Review of the application for a Wetlands Permit  
NHDES File Number: 2020-00183

Subject Property: 1A & B Old Runnels Bridge Rd, Hollis, Tax Map #10, Lot #33-1

Prepared by: Joseph Garruba  
28 Winchester Dr.  
Hollis NH 03049  
[Jm002@garruba.com](mailto:Jm002@garruba.com)  
603-685-3394

Date: April 17, 2020

Submitted site plan rev F dated 1/30/2020

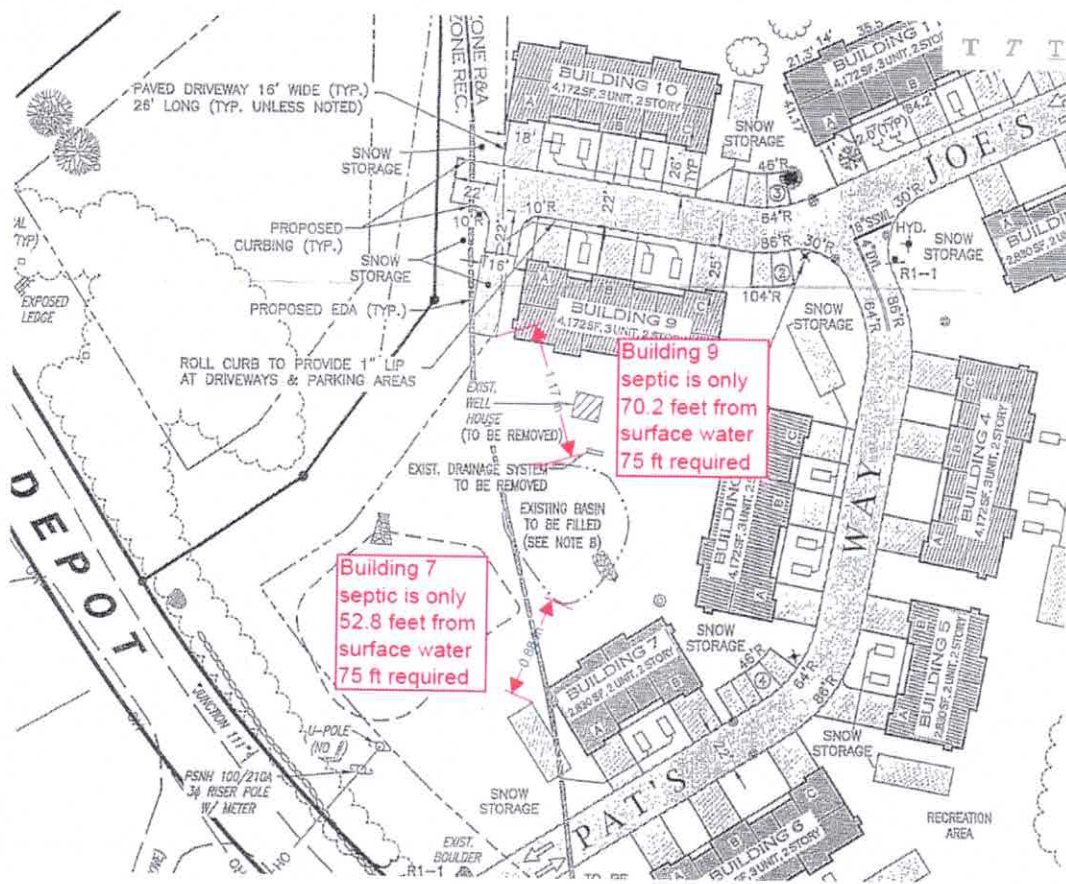
Using the submitted site plan rev F dated 1/30/2020 one can observe that the required 75 foot setback from surface water would not be met unless the southerly pond is filled. These setback violations effect water quality. Per Env-Wt 524.04 The project **shall** be designed to meet the criteria of item ( c ) and this is not the case with the present design.

Plan approved on 4-8-1998 showing southerly pond was not needed for storm water management and was added later for irrigation and as a golf course water hazard

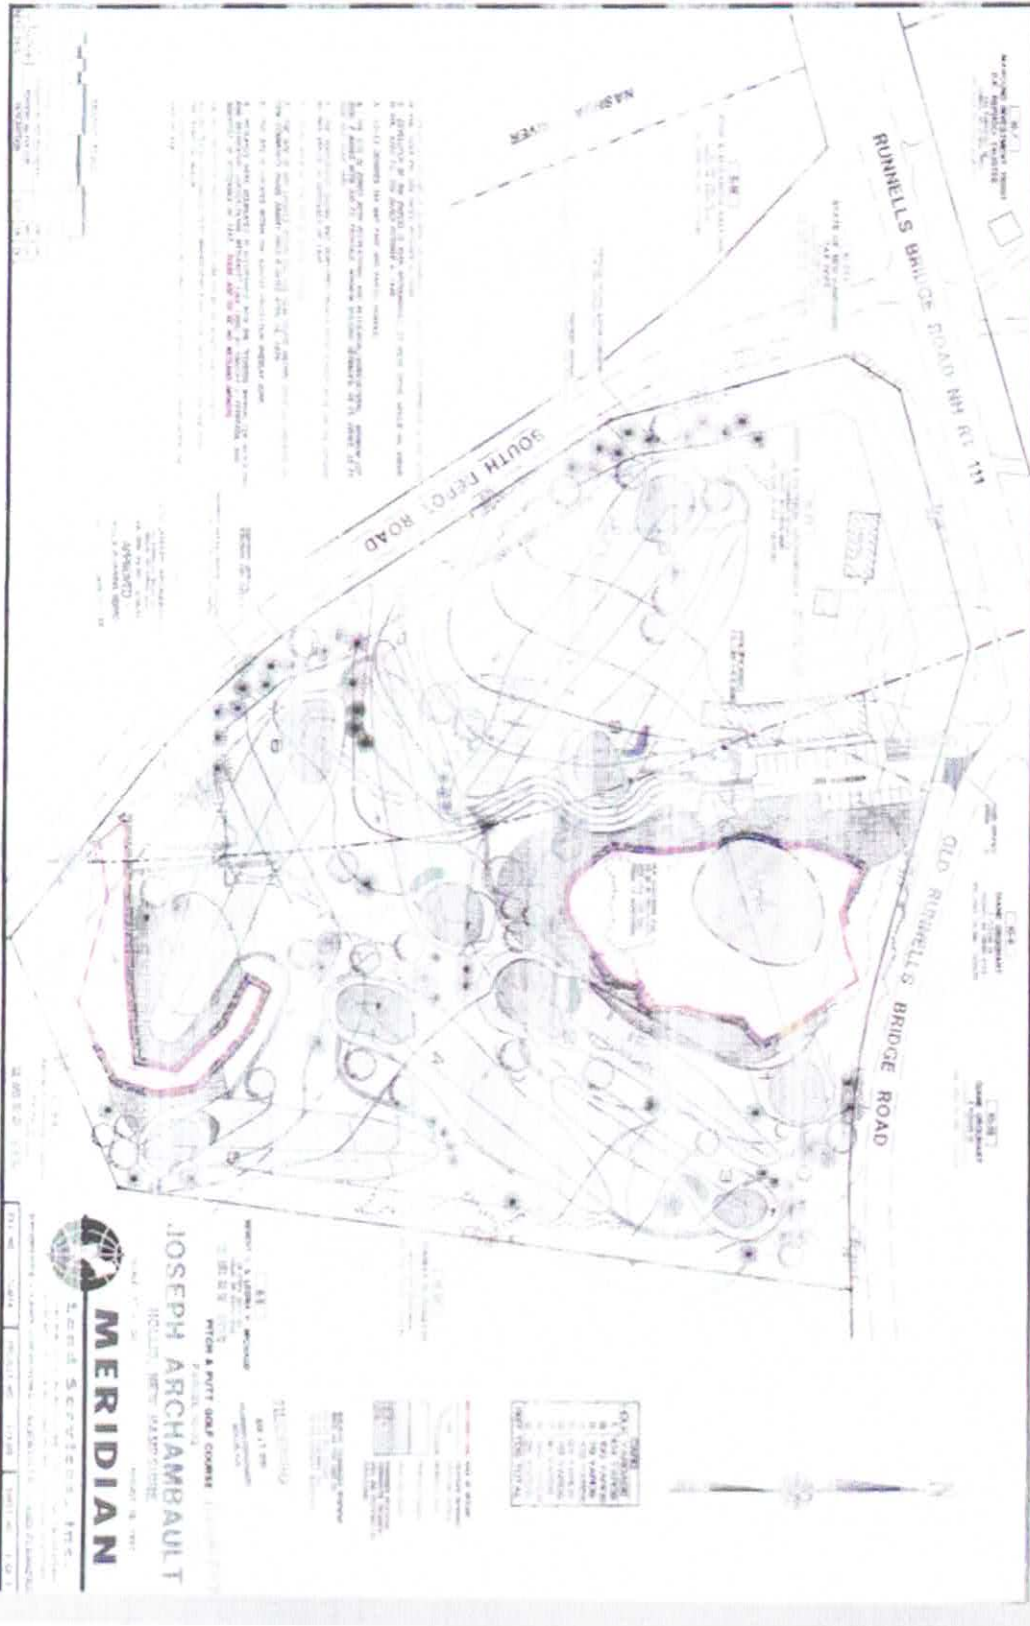
Finally, the southern pond has always been referred to as an irrigation pond. It was not constructed to handle storm water. This is proven by the letter from the planning board below. It is further reinforced by the fact that the golf course was approved originally without the southerly pond. If the southerly pond was required for storm water mitigation it would have been included in the original design

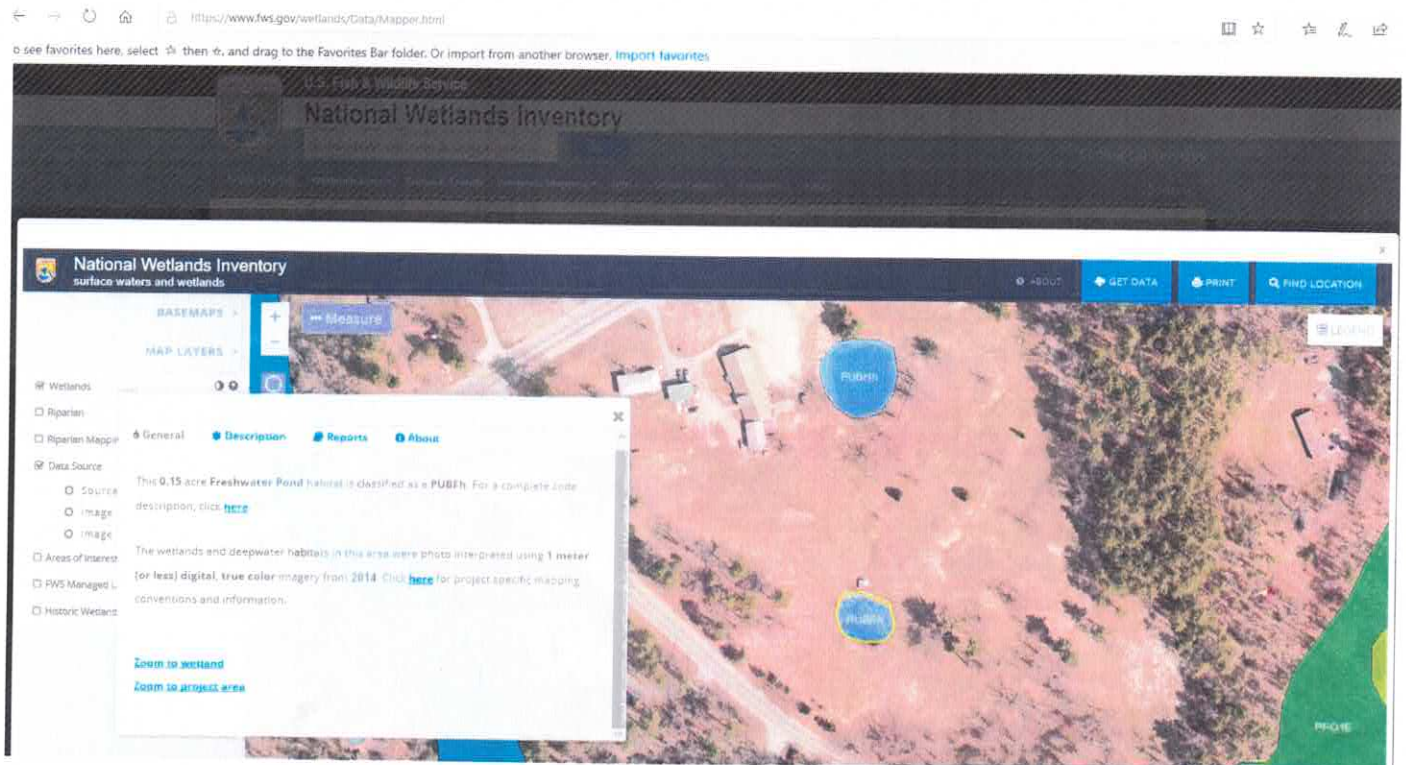
**Commented [u39]:** Is there a note on a drawing stamped by a certified wetland scientist indicating this?

The image below is taken from the National Wetlands Inventory website. It shows the limits of the bank of the southern pond as being considerably higher than the applicant's submitted plan. The area cited for the southern pond is .15 acres, not .077 as was reported in the applicant's map. It is understood that the NWI map is not to be the final answer when mapping the limit of a bank, but this info along with the subsequent aerial photo are proof that the limits of the bank of the southerly pond are variable and the normal level is greater than represented.

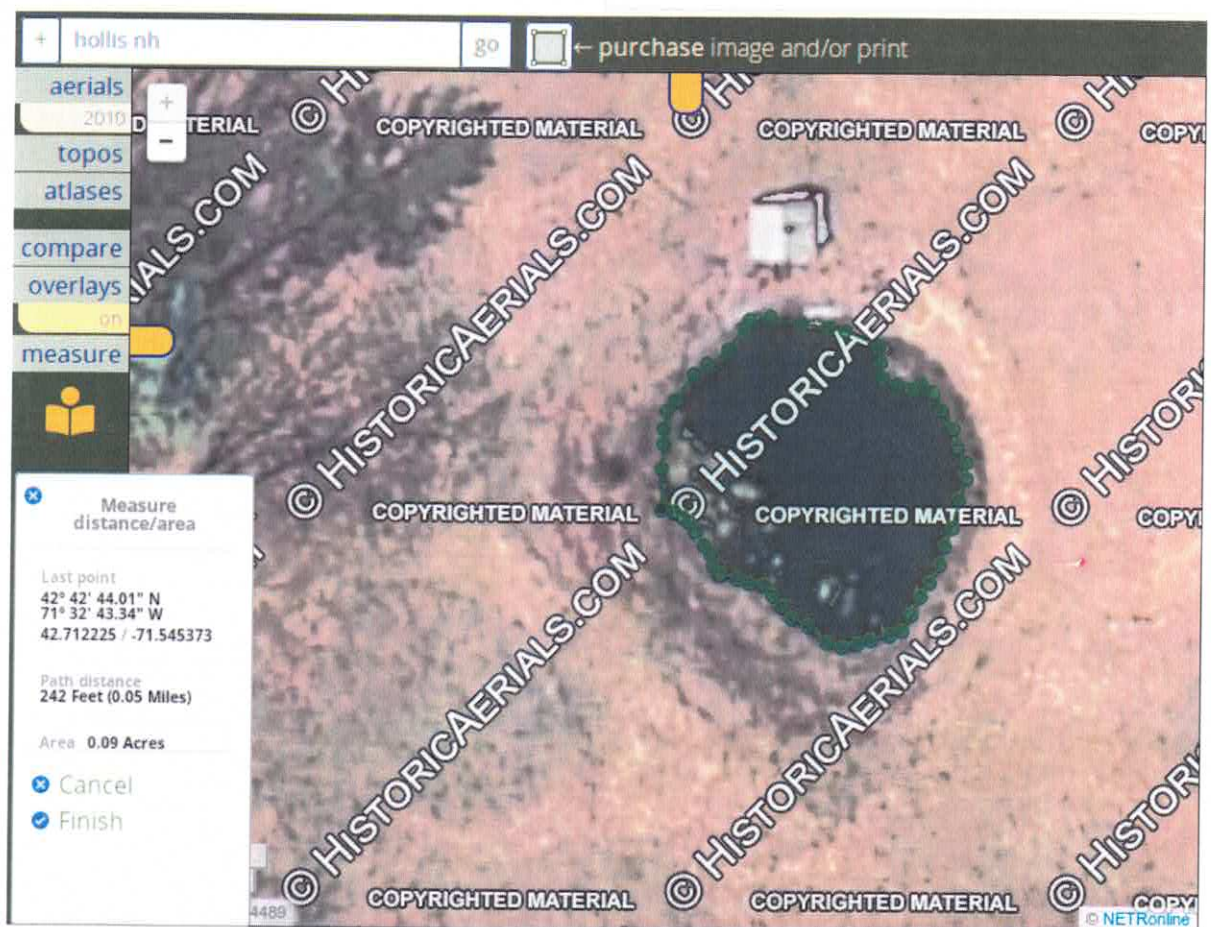
The image below represents a measurement made from a historic aerial photo of the southerly pond. From this photo, it is evident that the limits of the bank are variable and often are much higher than shown on the plans submitted. In this case, the limits of the bank show the area of the pond as .09 acres and not .077 as the applicant proposes
